No. EL/3.2.119/3-ph (TBU)

MODIFICATION SHEET No. RDSO/2015/EL/MS/0441 Rev. '1', Date 31.10.2018

Modification to avoid dropping of slack adjuster assembly (bottom) in case of breakage of its split pin in WAP7 type of three phase Electric locomotives.

Figure-1

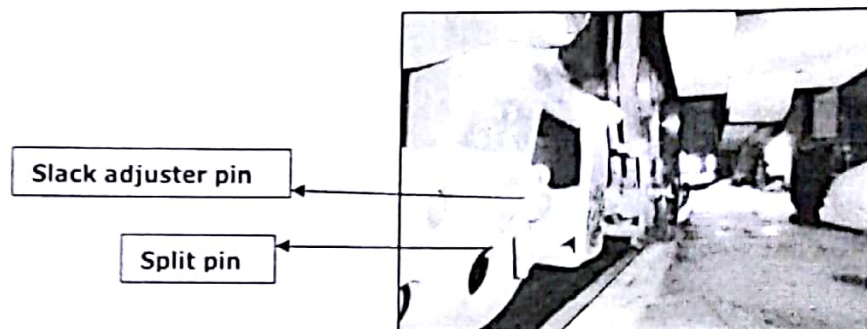
Slack adjuster assembly (bottom) is fastened with brake hanger by Slack adjuster pin of size M28 x 89 mm and split pin of size 10 x 63 (Ref Nos. 51 & 53 of RDSO Drg. No. SK.VL-584 Alt.2) as depicted in Figure-1:

Figure-3 (Modified)

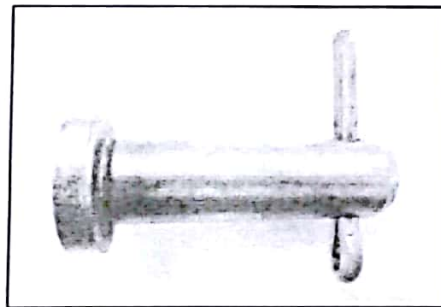
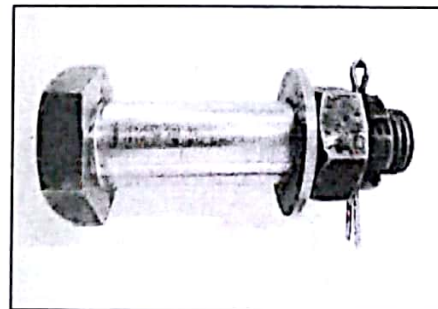
4.0 **Modified arrangement:** In place of slack adjuster pin with split cotter pin as shown in Figure -2, Hex. head bolt with plain washer, castle nut and split pin to be provided as shown in Figure-3:

Existing Slack adjuster pin with split cotter pin are to be removed. Hex. head bolt with plain washer, castle nut and split pin as per RDSO drawing no. SKEL-5004 Alt. 2 or latest is to be provided in Slack Adjuster assembly (bottom).

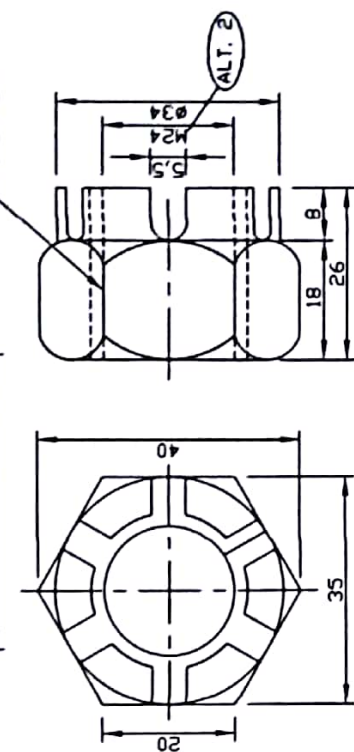
STATUS	ALT	REF. NO.	DESCRIPTION	APPD. BY	DATE
2.			CLV Letter No.ED/7750/p18 B BOD/9/18	DIRECTING HQ, No. 403, PAVO B. 402, Pav. 2, 75, No. #24, PVO, 408, Puch. 3, #29, #30, 4 & 68 respectively	[Signature]	09.10.2018
1.				NOTE 3 ADDED & CHANGFERING AT "X" & "Y"		26.10.2015
